**regulatory paths to a more diverse housing stock:
encouraging family-sized, single-stair apartments in
Seattle's single-family neighborhoods with the
Urban Residential zone**

Emily Pressprich

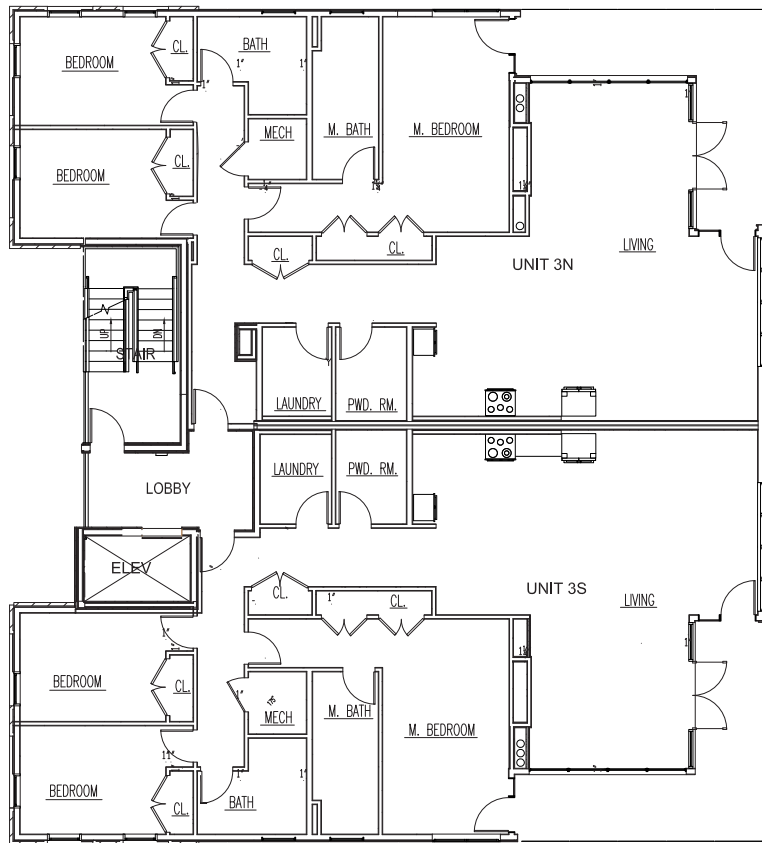
Figure 12: Typical floor plan for 2514 Dexter Ave N ("Plan Review No. 77554, Automatic Sprinkler System, 2514 Dexter Avenue North - Dexter Avenue Condominiums" 2021).

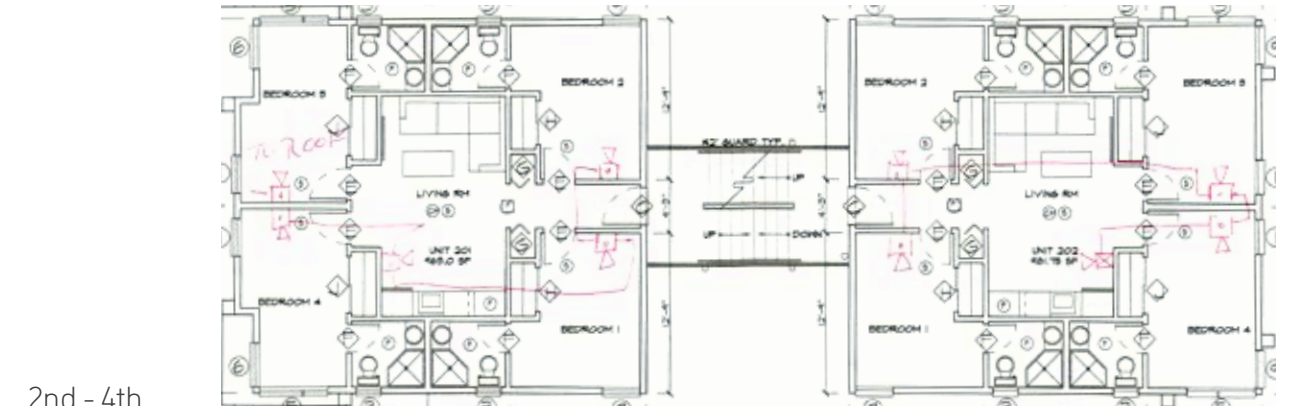
Figure 43: (below) floor plans for 5234 15th Ave NE ("Plan Review No. 63920, Fire Alarm System, 5234 15th Av NE" 2018). Note that this is the same plan, from the same developer, as 4215, 4219, and 4221 9th Ave NE.

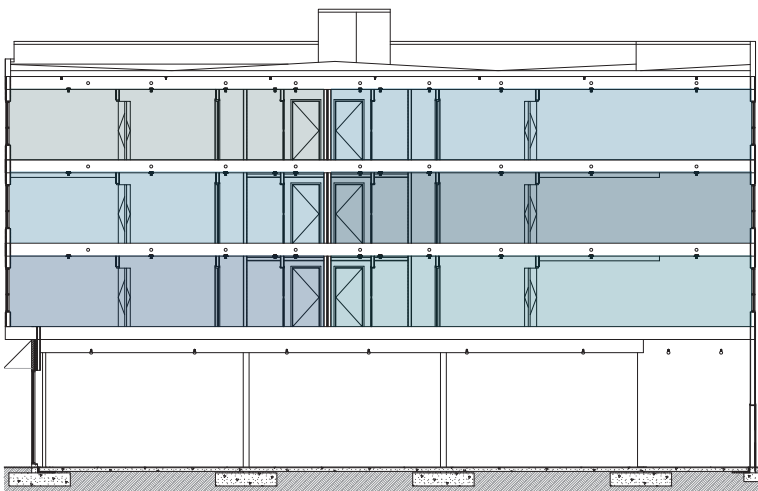
Figure 64: Section showing 3 floors of residential over first floor commercial space ("Plan Review No. 63480, Automatic Fire Sprinkler and Standpipe System - Nem, Rainier Ave Mixed-Use" 2017).

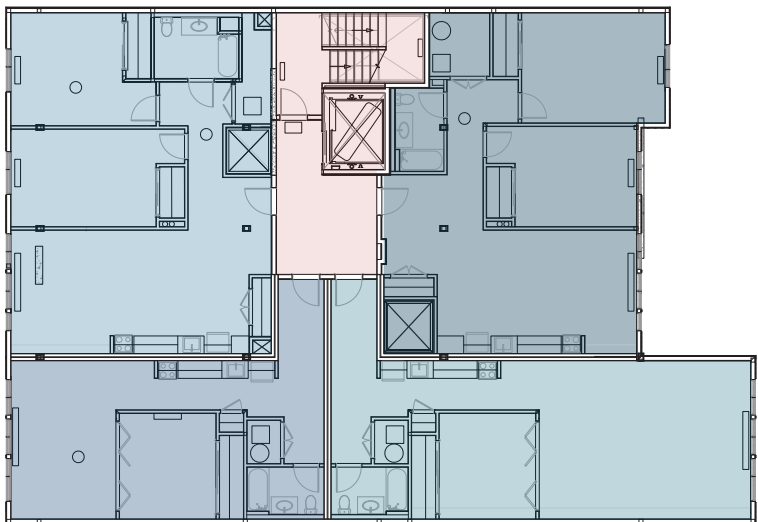
Figure 65: Upper level plan showing 1 & 2 br units ("Plan Review No. 63480, Automatic Fire Sprinkler and Standpipe System - Nem, Rainier Ave Mixed-Use" 2017).
